Westfield City Council Report

Ordinance Number:	14-50
APC Petition Number:	1412-PUD-18
Petitioner:	Langston Development, LLC by Faegre Baker Daniels, LLP
Requested Action:	A change of zoning from the AG-SF1: Agriculture / Single-Family Rural District to the Mapleridge Planned Unit Development (PUD) District.
Current Zoning:	AG-SF1: Agriculture / Single-Family Rural District
Current Land Use:	Residential / Agricultural
Exhibits:	<ol style="list-style-type: none">1. Staff Report2. Location Map3. Concept Plan Exhibit4. PUD District Ordinance5. Neighbor Meeting Summary6. Public Comments (written)7. Petitioner's Update8. APC Certification
Prepared by:	Jesse M. Pohlman, Senior Planner

EXHIBIT B - MAPLERIDGE CONCEPT PLAN

EXHIBIT B MAPLERIDGE CONCEPT PLAN

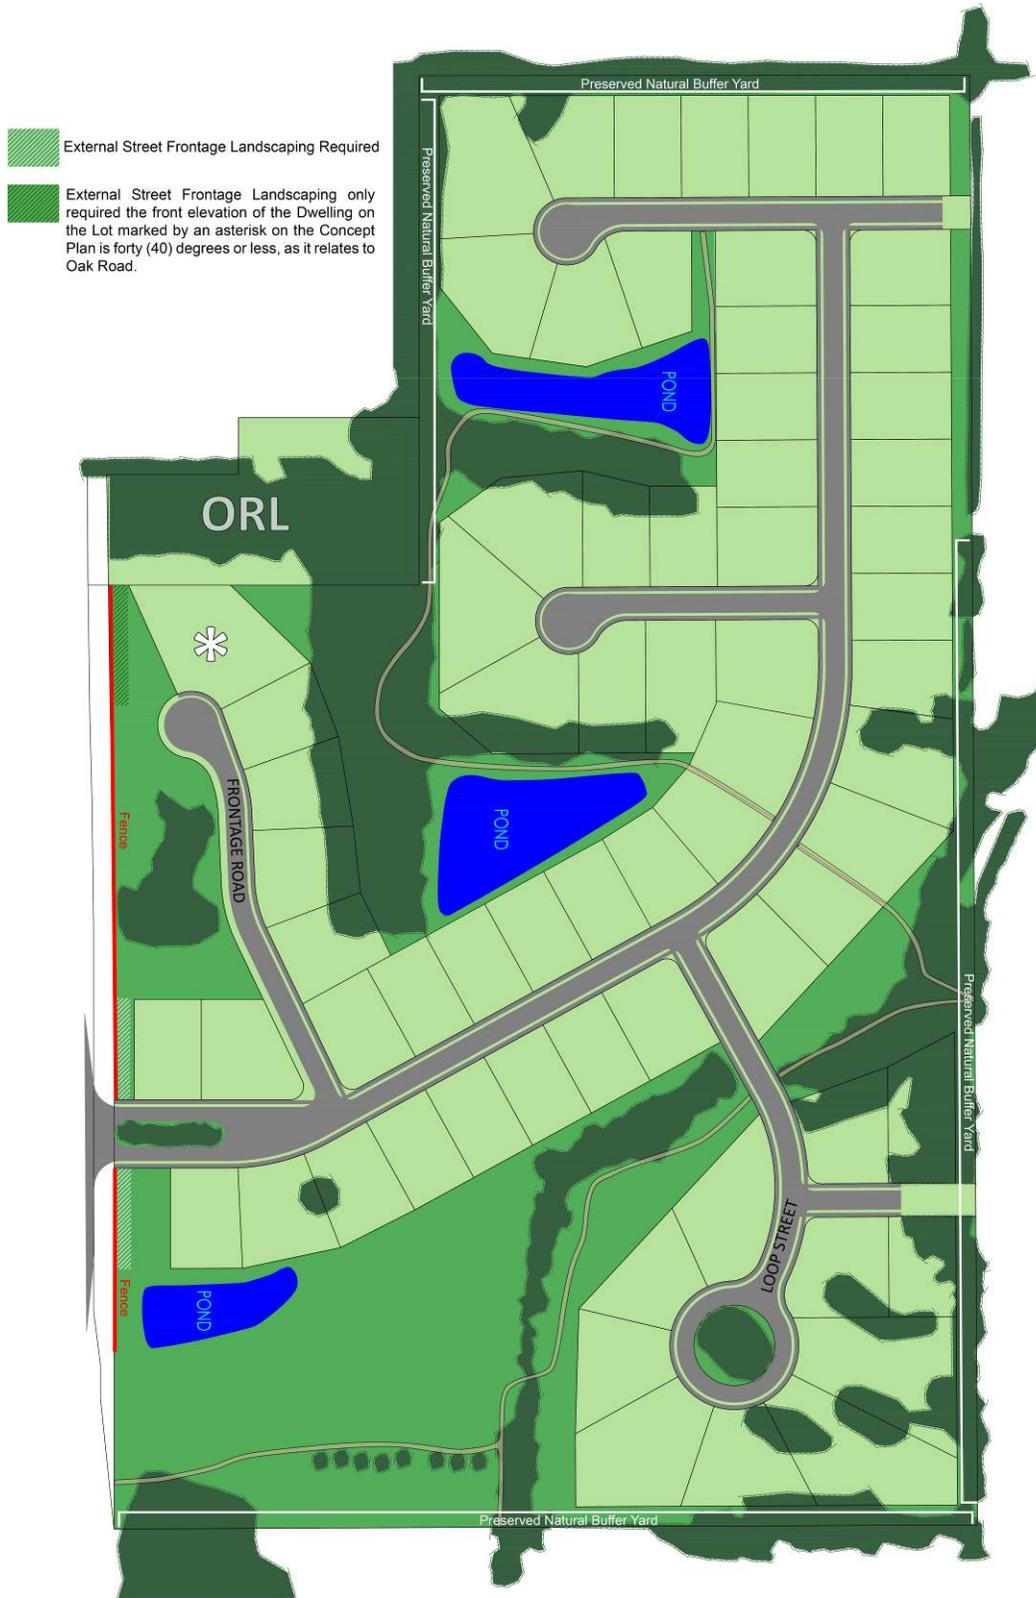
In response to comments received, the referenced Character Exhibits also incorporate side and rear facades so the established benchmark also applies to the rear and side facades of homes. As a result of the revisions to the Concept Plan since the Council introduction, the rear of homes will no longer be oriented towards Oak Road.

1. Street and Right-of-Way Standards (Article 8.9): In working with the Department, Public Works Department, and the Fire Department, the Petitioner has modified the Concept Plan since the Council introduction. The revised Concept Plan now includes a loop road (rather than cul-de-sac) and stub street at the southeast corner of the property.

The loop road is planned as one-way street that will better accommodate (compared to the prior design) emergency response equipment while also allowing for the preservation of existing trees. The cross-section and final design of the loop road will be determined in coordination with the Fire Department and Public Works Department at the time of the overall development plan and primary plat review.

The Concept Plan also includes two stub street locations, which are generally located at the northeast and southeast corners of the property. The exact location of the stub streets may vary at the time of the primary plat review, but the requirement for the stub has been included in the revised ordinance to meet the UDO’s requirement for connectivity to adjacent properties. In addition, language has been added to the proposed ordinance to require a pedestrian and alternative emergency access path to connect the proposed frontage road to Oak Road.

In working with the Department, the Petitioner has incorporated a requirement into the PUD Ordinance for trails internal to the development. The potential locations of internal trails have been depicted on the revised Concept Plan. The exact location will be determined at the time of the overall development plan and primary plat review upon final engineering; however, in response to comments from neighbors, the PUD Ordinance includes language that prohibits these trails along the north property line of the District. Trails internal to the District will provide access and connectivity of the preserved Natural Areas and Open Space so these areas better function as an amenity.

3. Floodplain: The Concept Plan has been revised as a result of the new Flood Insurance Rate Maps (FIRM), which became effective on November 19, 2014. The exact location of the floodplain will be reviewed at the time of the overall development plan and primary plat review. Any proposed development that would be determined to occur within the floodplain will be subject to both local and state regulations, including review and approval by the State of Indiana and the City of Westfield (see Article 5.5 Floodplain Overlay District of the UDO).

1. Neighbor Requests:
 - a. Oak Road Fence. At the request of the neighbors, Langston has agreed to install a fence along the Oak Road perimeter. This has been incorporated into the PUD Ordinance (including a character image of the proposed fence) and is shown on the Concept Plan.

- d. Neighborhood Entrance. To address concerns about the location of the neighborhood entrance, Langston has agreed to move the proposed entrance. This is now depicted on the Concept Plan that is included as an exhibit to the PUD Ordinance.
